STATE OF MAINE
DEPARTMENT OF TRANSPORTATION
16 STATE HOUSE STATION
AUGUSTA, MAINE 04333-0016

January 22, 2018
Subject: Billings Bridge
Superstructure Replacement
State WIN: 022618.00
Location: **Paris**
Amendment No. 2

Filename: ... \MSTAN022_consdetails_01.dgn

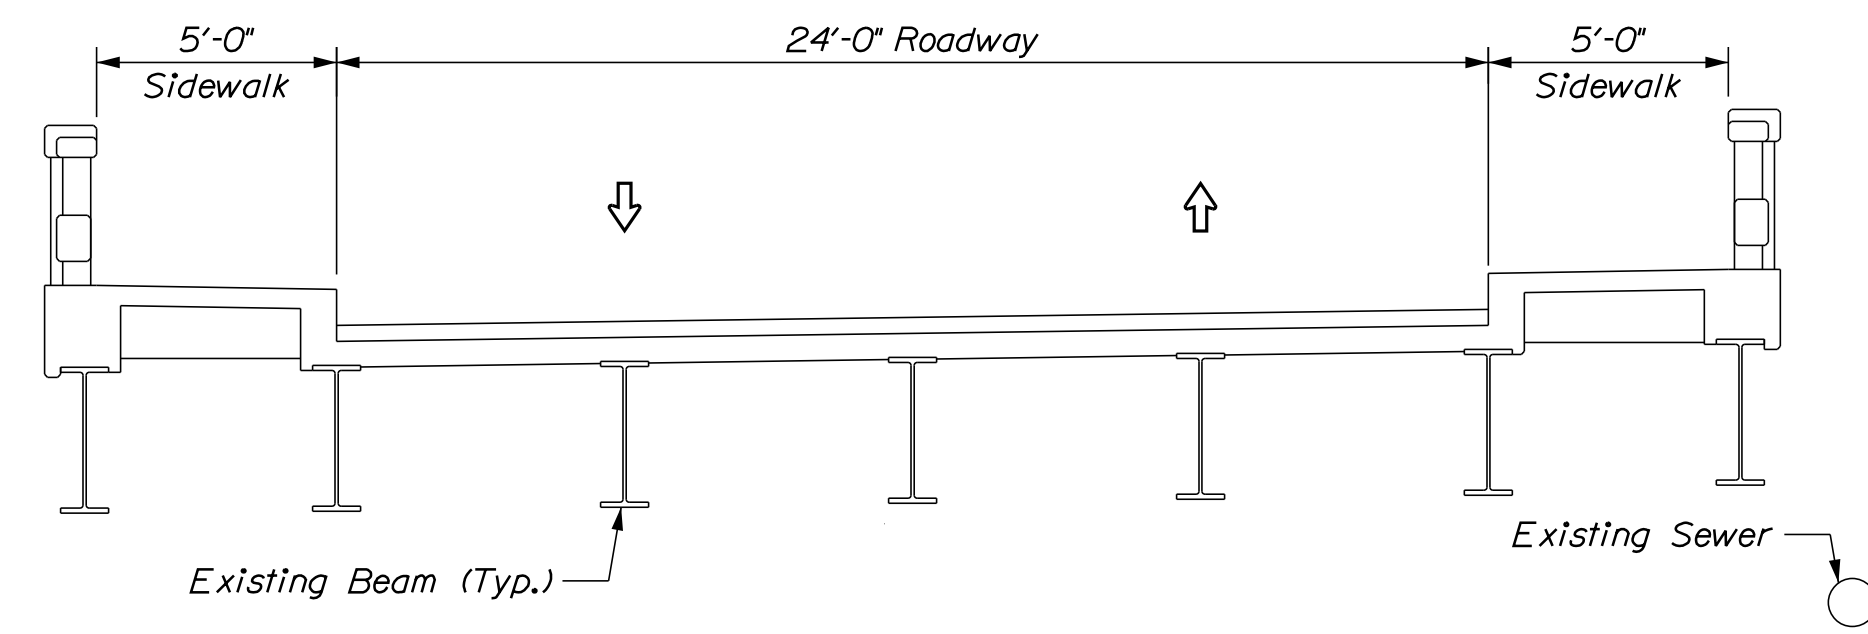
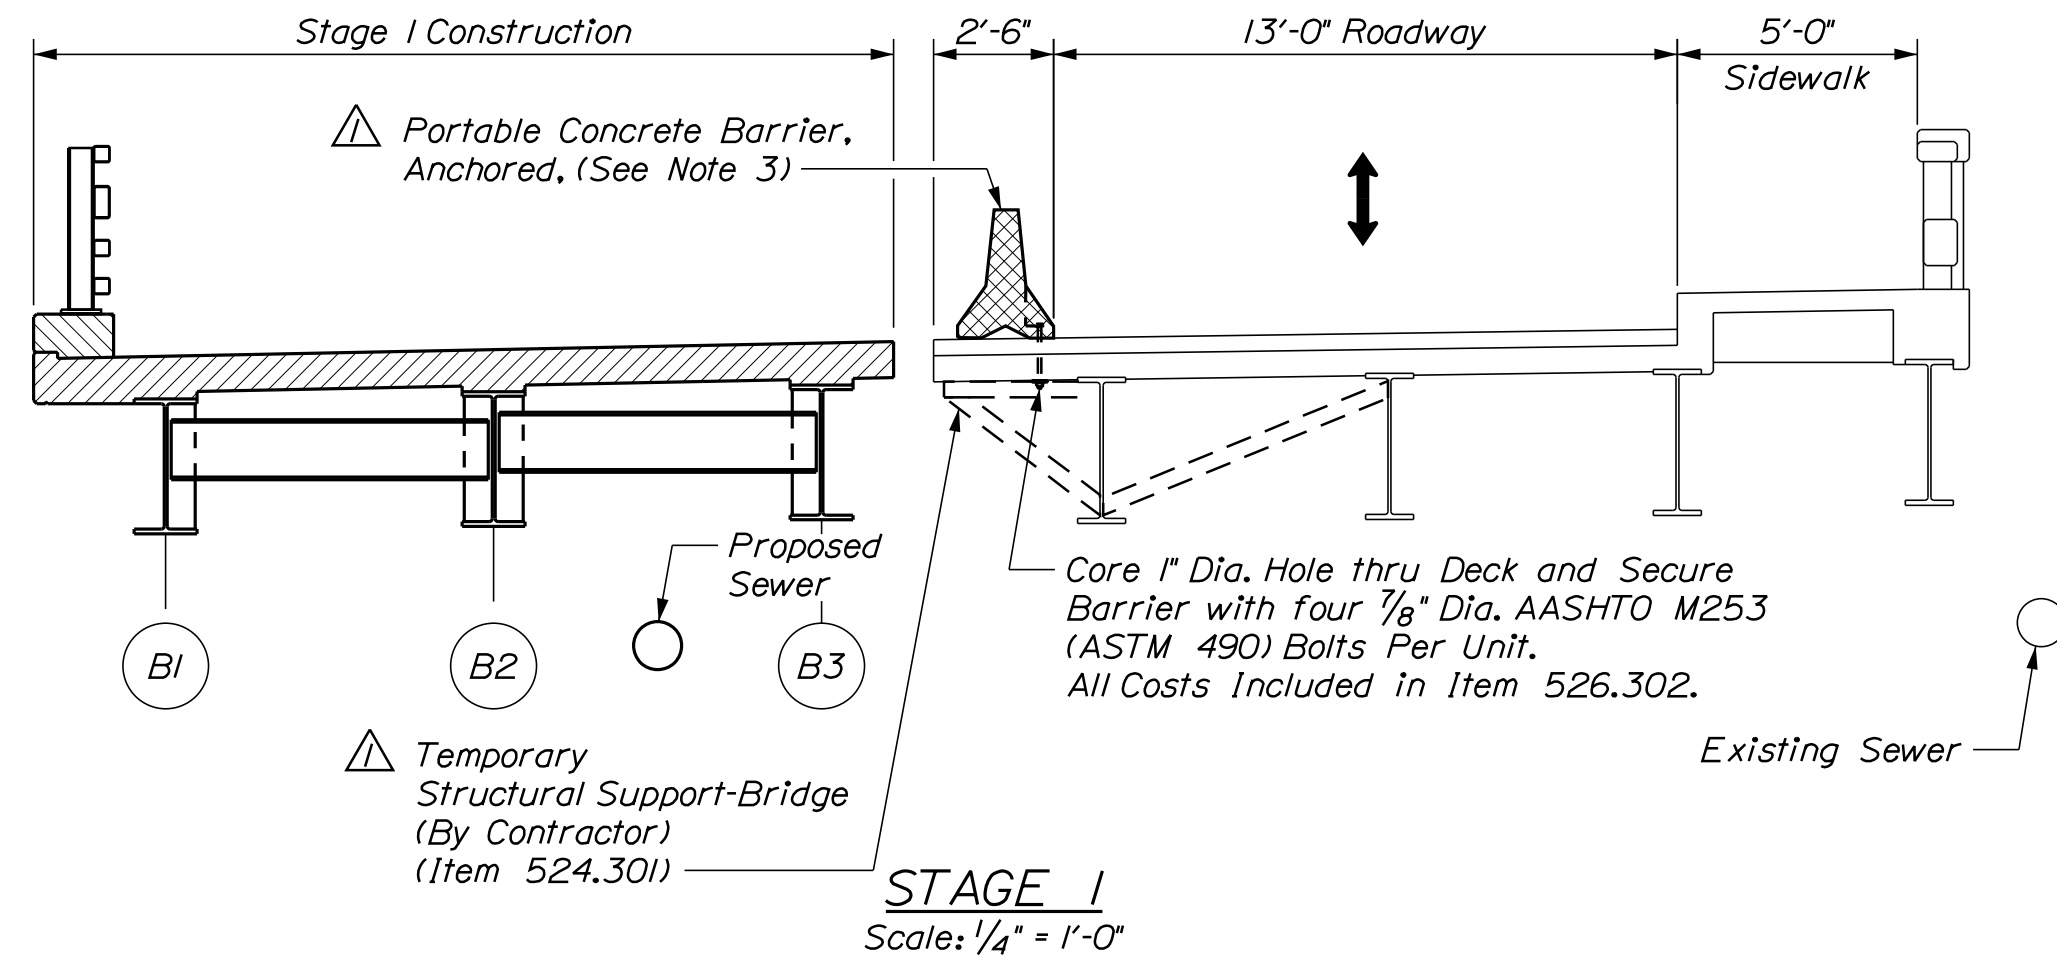
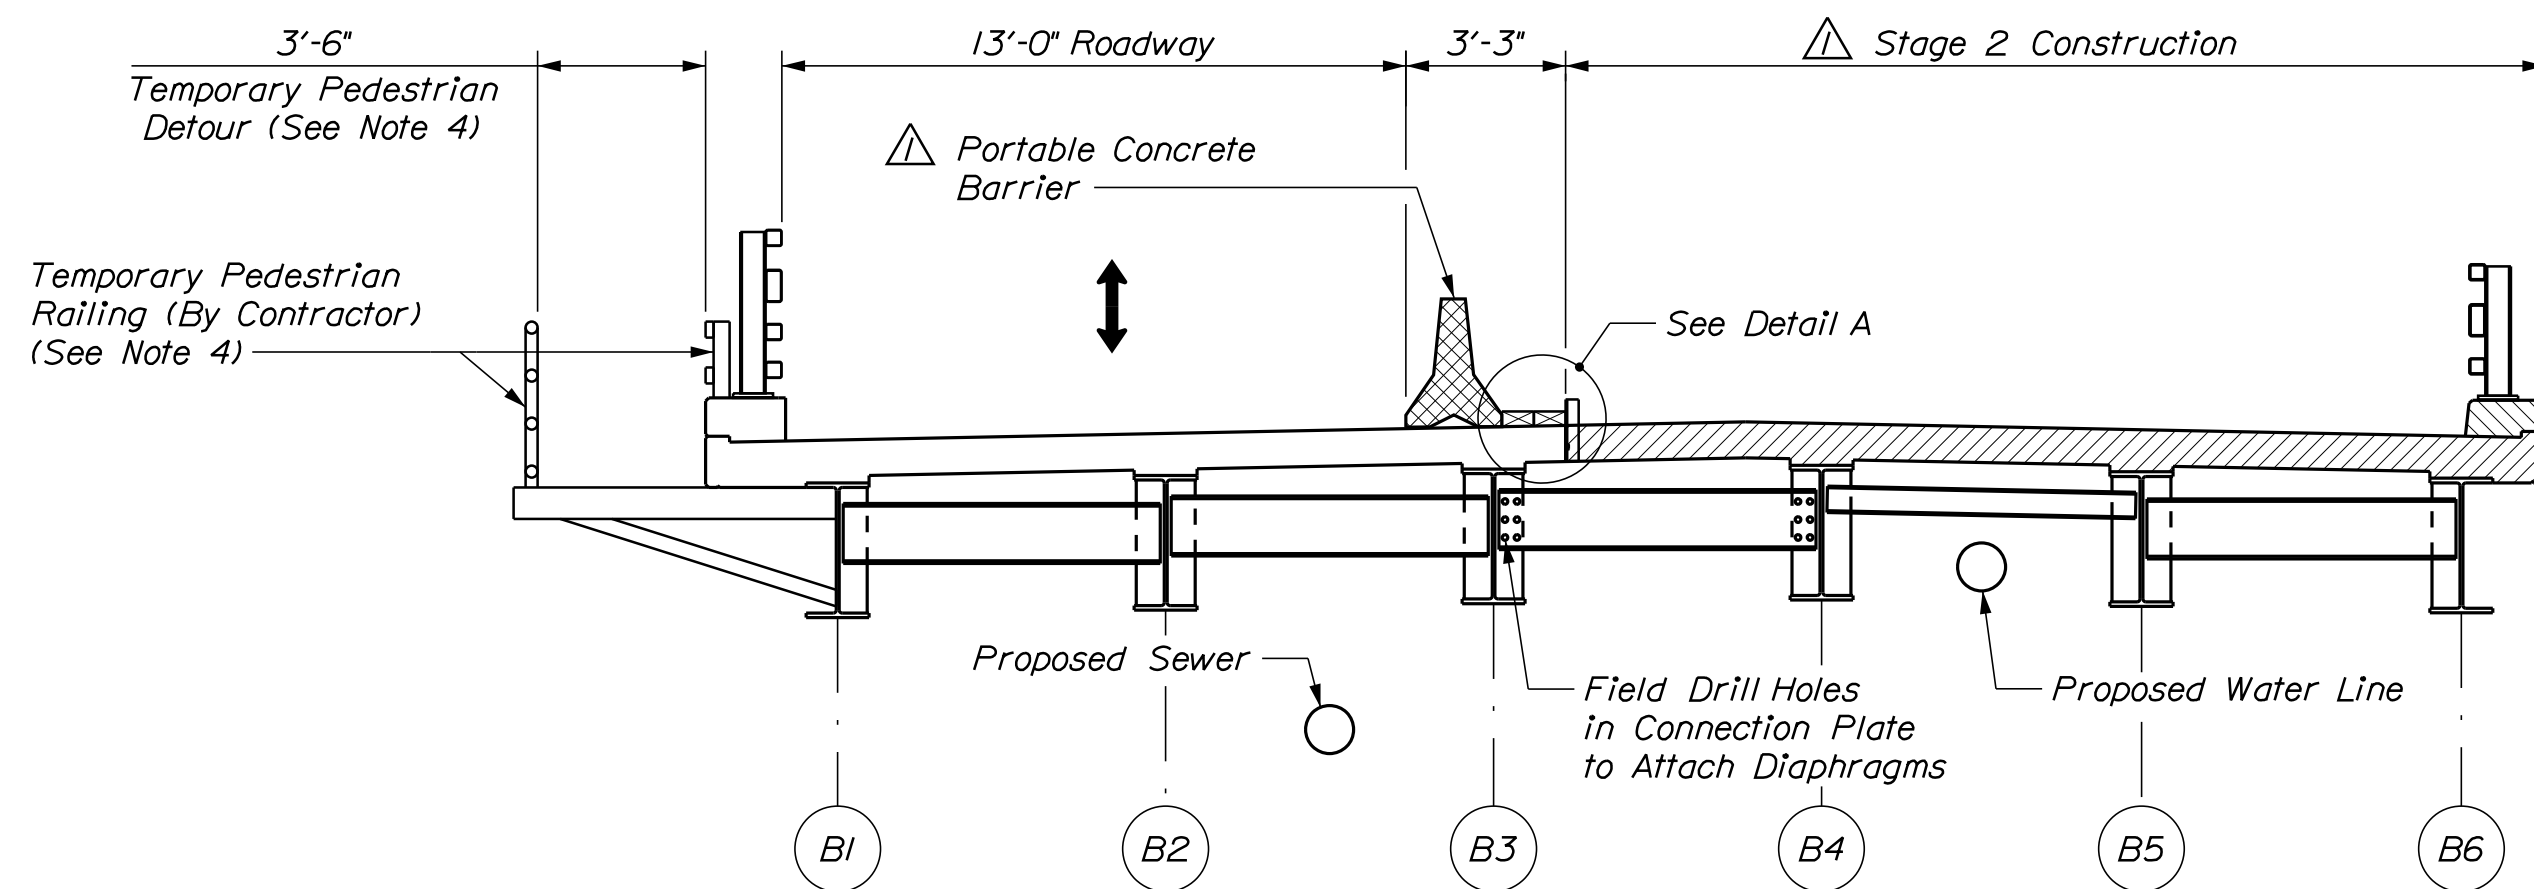
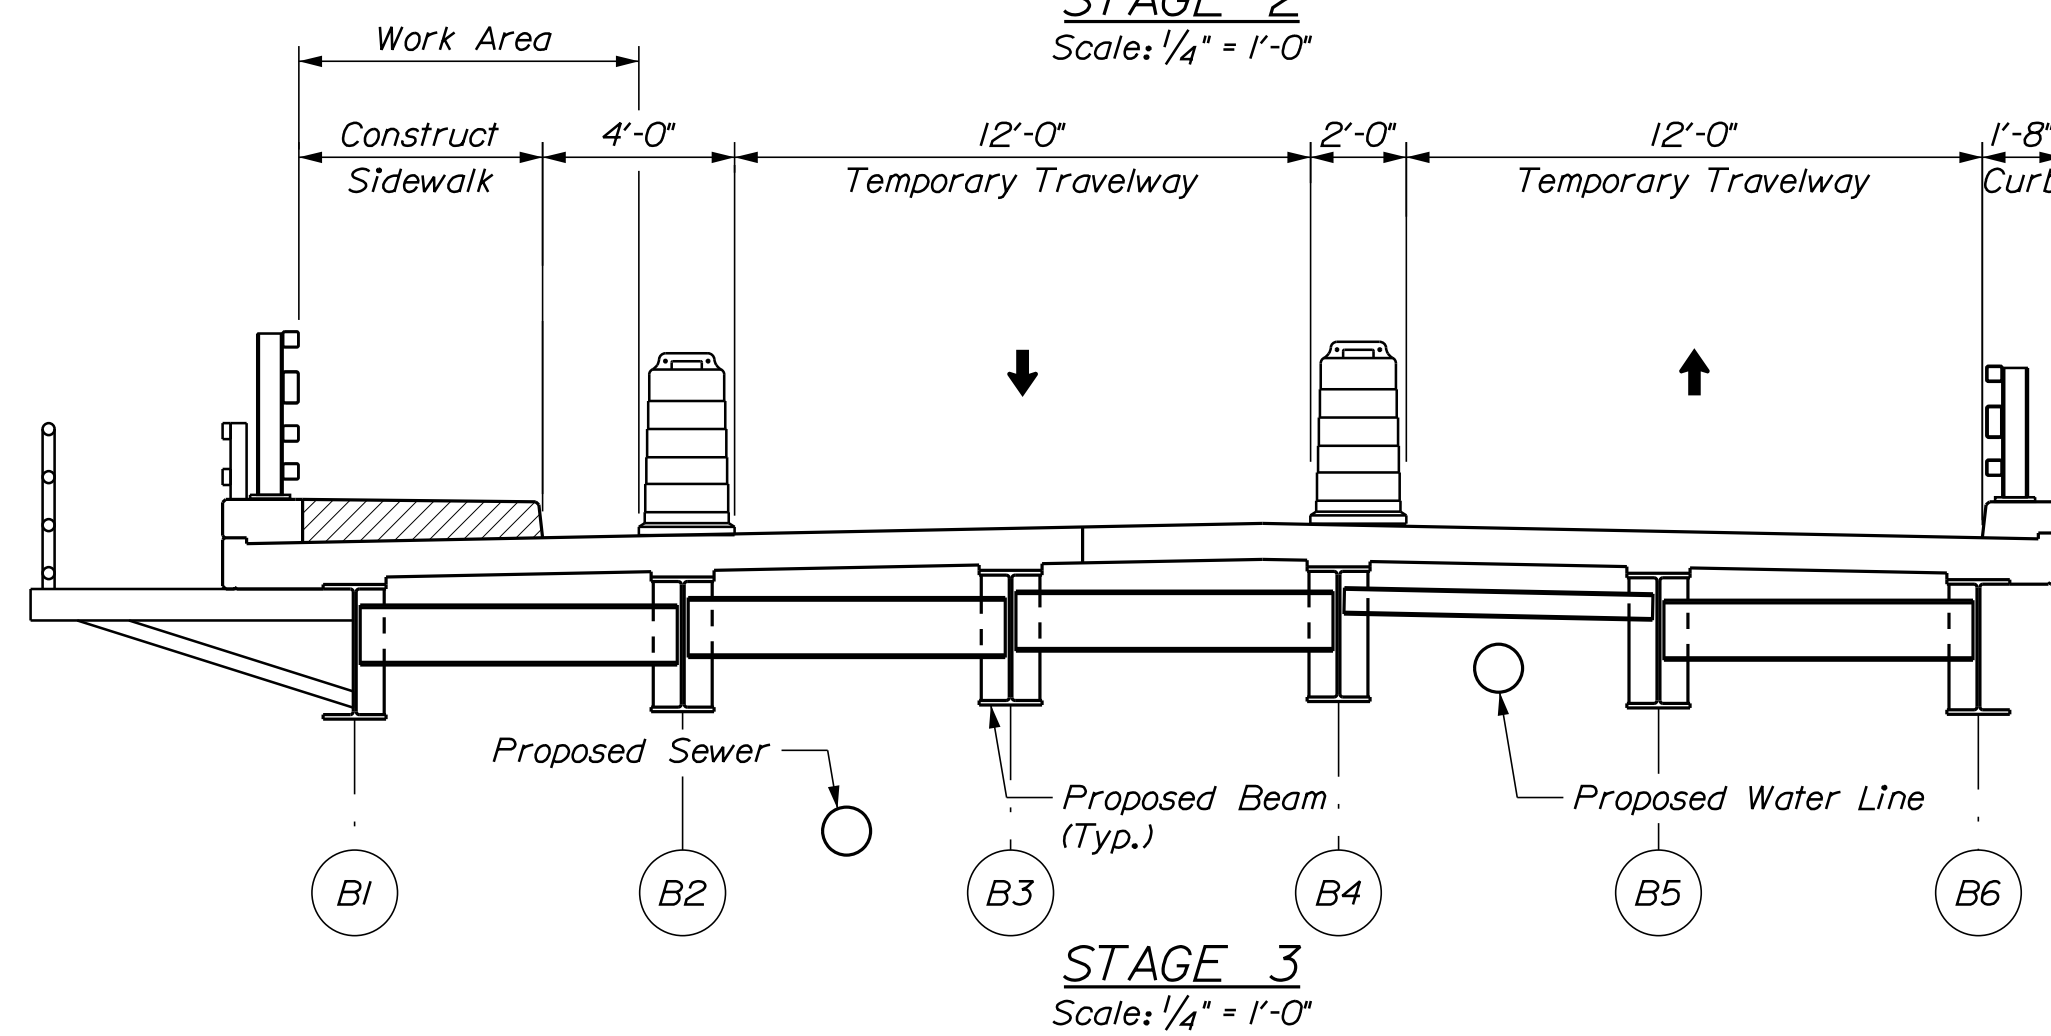
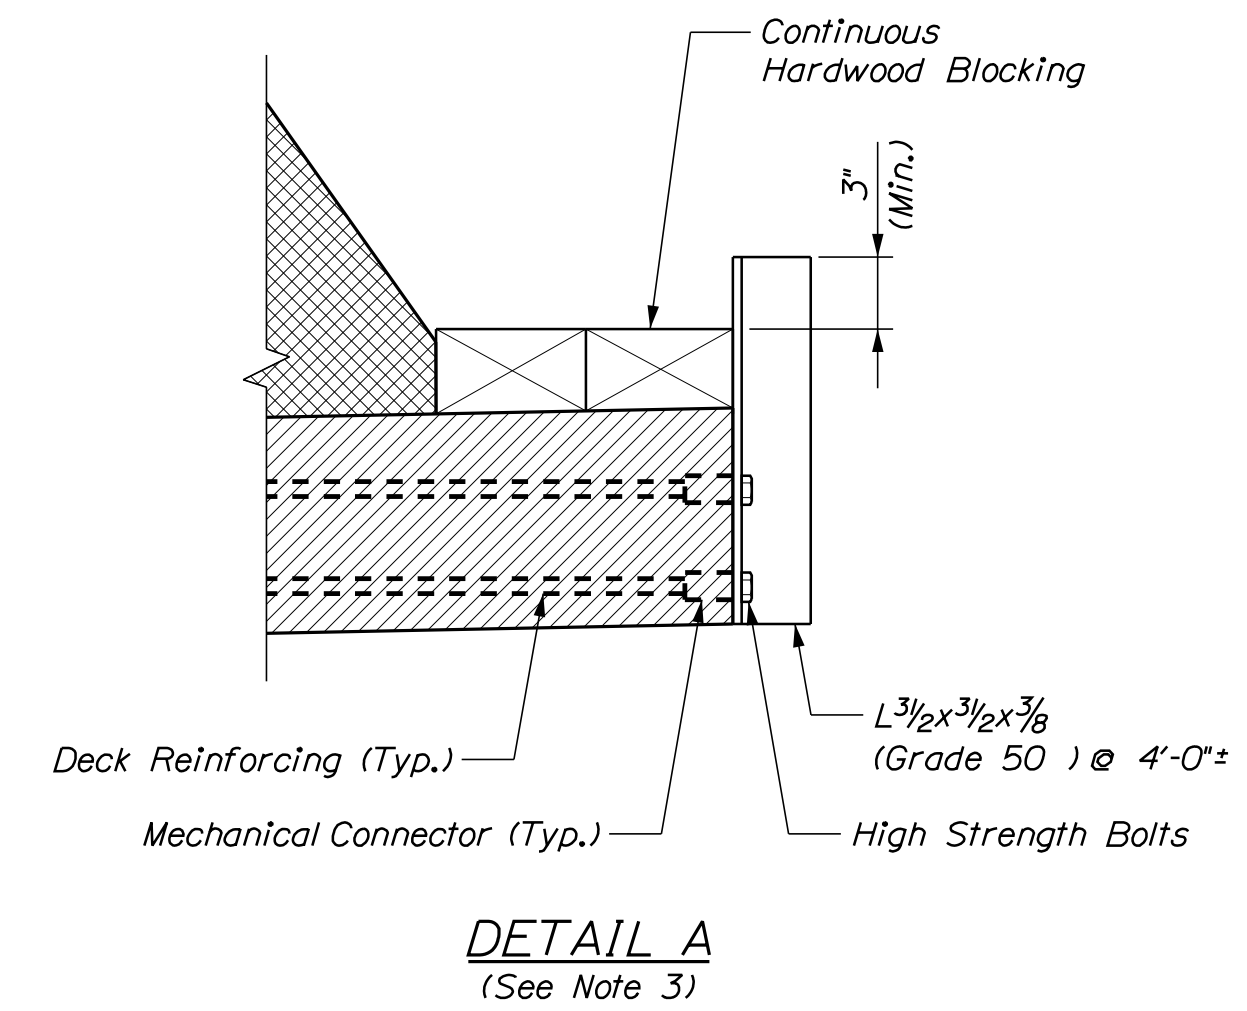
REMOVE SHEET NUMBER 22 OF 57, STAGED CONSTRUCTION DETAILS, and **REPLACE** with the attached, revised SHEET NUMBER 22 OF 57, STAGED CONSTRUCTION DETAILS.

5. See Temporary Signal Plans sheet for additional information.
6. Install diaphragms between B3 and B4 prior to forming Phase 2 Deck Placement. Field Drill connection plate on B3 or B4 using holes in diaphragm member as a template.
